Amendments to the Drawings

Remarks/Arguments

FIG. 11 Prior Art

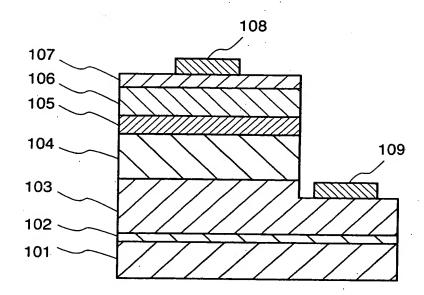
Figures 11 and 12 are objected to under MPEP 608.02(g) for lacking a legend such as "Prior Art". In response, Figures 11 and 12 are amended to include the legend "Prior Art". The drawings are further objected to under 37 CFR 1.84(p)(5) for lacking reference sign 110. In response, Figure 12 is amended to include reference sign 110. A replacement sheet with the corrections to Figures 11 and 12, and an annotated sheet showing the changes, are enclosed.

The attached sheet of drawings includes changes to Figs. 11 and 12. This sheet replaces the original sheet including Figs. 11 and 12. In Figs. 11 and 12, the legend "Prior Art" has been added. In Fig. 12, previously omitted reference sign 110 has been added.
